August 9, 2024

Re: **Response to TEP Comments – Vadnais Heights Apartments Wetland Replacement Plan
 (LGU file 7.2024)
 Vadnais Heights, Minnesota**

On behalf of Rueter Walton, Braun Intertec has responded below to the TEP comments on the Vadnais Heights Apartments Wetland Replacement Plan. Each number in the list below corresponds to the comments received in Findings Regarding the Vadnais Heights Apartments (Replacement Plan) Project, Project No. 7.2024, dated August 1, 2024.

Figure 5. Off-Site Alternatives

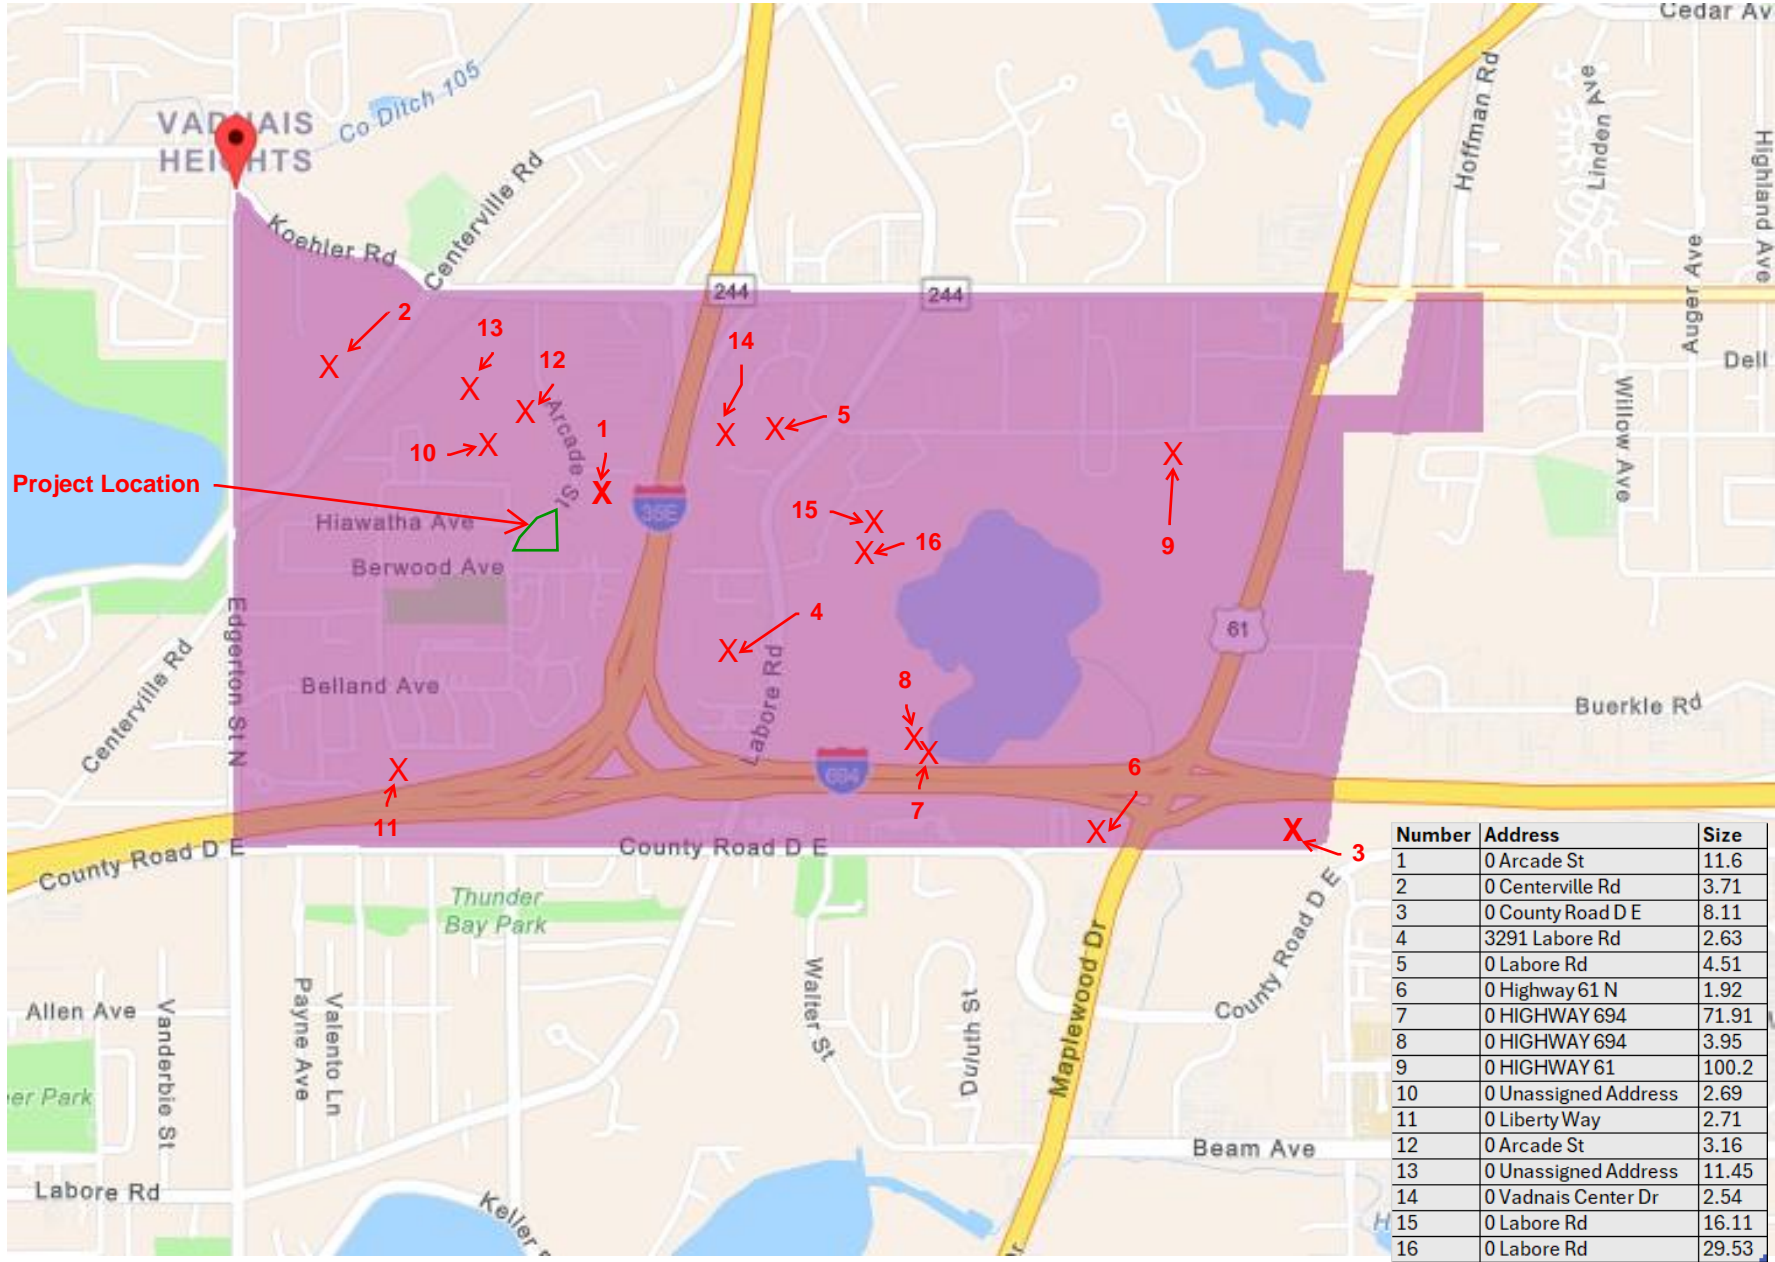
3. Landownership and the willingness to sell is the necessary first step in determining if an alternative site can be considered for a potential project. It is not reasonable for the TEP to assume that a property can be a viable alternative if the current owner is not willing to sell. The applicant has provided two alternative sites in the application that would meet the project purpose and need, and demonstrated why these alternative sites did not advance. The two alternative sites and QCT area are illustrated on Figure 5 of the application.

Additional available properties that meet site selection criteria (refer to Attachment C of the application) for undeveloped parcels that are a minimum of 1.5 acres within the QCT are provided below and on the revised Figure 5. These alternative sites are not being marketed for sale. Most are surrounded by industrial uses and have no connection to transit, grocery, and other amenities. Other sites lack access or are City owned sites in which the City is not a willing seller.

- 0 Centerville Road (11.6 acres): No access (landlocked)
 - 3291 Labore Road (2.63 Acres): Surrounded by industrial uses, no connection to grocery, transit, other amenities.

- 0 Labore Road (4.51): Surrounded by industrial uses, no connection to grocery, transit, other amenities.
 - 0 Highway 61 N. (1.92 acres): Land used by the State for the freeway.

- 0 Highway 694 (71.91 acres): No Access, land locked, no connection to grocery, transit or other amenities.
 - 0 Highway 694 (3.95 acres): No Access, land locked, no connection to grocery, transit or other amenities.

- 0 Highway 61 (100.2 acres): Expansive wetlands and one large contiguous parcel.
 - 0 Unassigned Address (2.69 acres): City owned and not interested in selling. Not buildable (existing stormwater pond).

- 0 Liberty Way (2.71 acres): Long, thin lot between Interstate 694 and single-family homes. Land locked and no access.
 - 0 Arcade St (3.16 acres): City owned and not interested in selling.

- 0 Unassigned Address (11.45 acres): City owned and not interested in selling. Not buildable (existing wetlands).
 - 0 Vadnais Center Dr (2.54 acres): Surrounded by industrial uses, no connection to grocery, transit, other amenities.

- 0 Labore Rd (16.11 acres): Surrounded by industrial uses, no connection to grocery, transit, other amenities.
 - 0 Labore Rd (29.53 acres): Surrounded by industrial uses, no connection to grocery, transit, other amenities.

C3-1

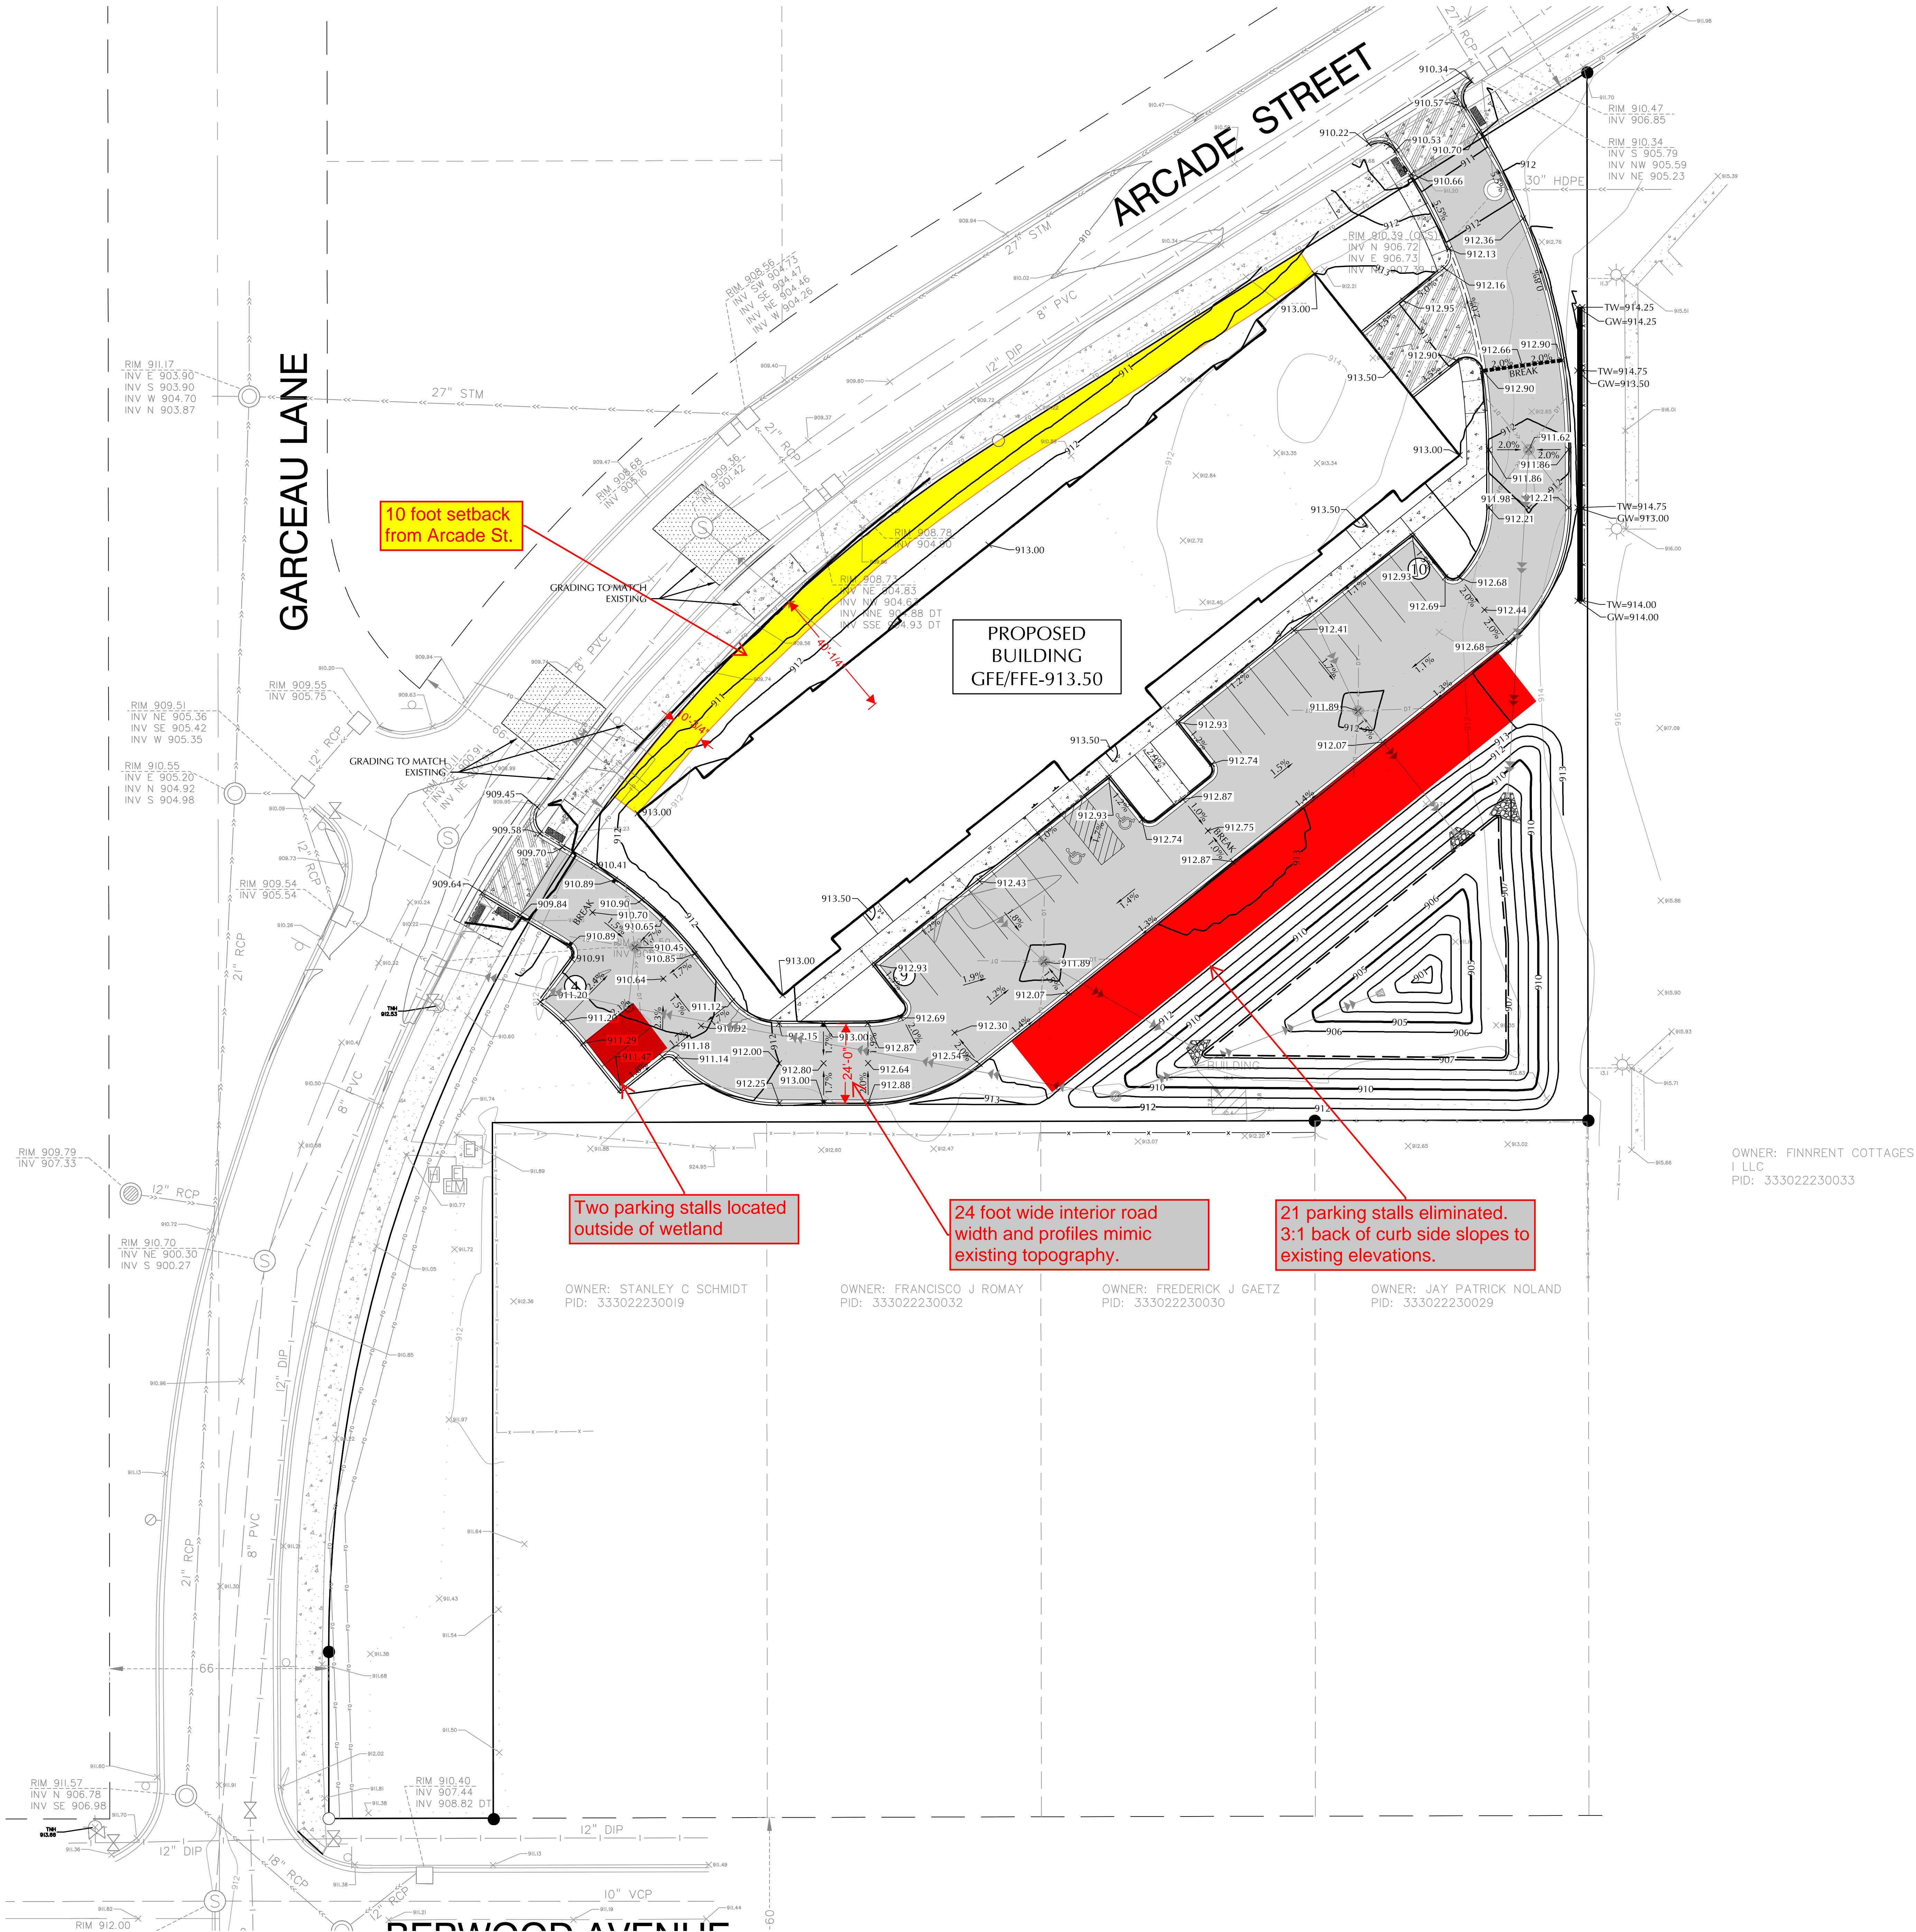
7. Visual representation of the minimization efforts (Attachment C of the application) is attached as Sheet C3-1 Grading Plan.
8. TEP comment is subjective. Site selection was based on several factors (as outlined in Attachment C of the application). Net acres of developable land (≥ 1.5 acres) is one parcel (or contiguous adjacent parcels) that meet the minimum site selection criteria for the project to be feasible. The location of existing structural and natural features (site constraints) are documented and explained in the application (Attachment C).

11. Duplicative stormwater comment (refer to comment response #2).
12. The proposed stormwater pond outlet elevation and normal water elevation is 906.75' MSL (5.75 feet deep) with a high water elevation of 909.10' MSL (refer to Sheets C3-1 Grading Plan and C4-2 Storm Sewer Plan in Appendix B of the application). The delineated wetland elevations range from approximately 910.89' to 913' MSL with an existing outlet elevation of 910.20' MSL (as shown on the new attached Sheet C1-1 Site Demolition Plan). Wetland A hydrology for the 0.08 acres remaining will be sustained by existing ground water (approximately 906 - 909.5' MSL) and increased volume of treated surface water runoff from land cover changes (0.346 acre-feet from existing pervious surfaces conversion to 0.459 acre-feet impervious surface post-construction for the 10-year storm event). The proposed condition results in a decrease of site runoff rates for the 1, 2, 10, and 100 year storm events (Tables 1.1 and 1.2 in Attachment C of the application).
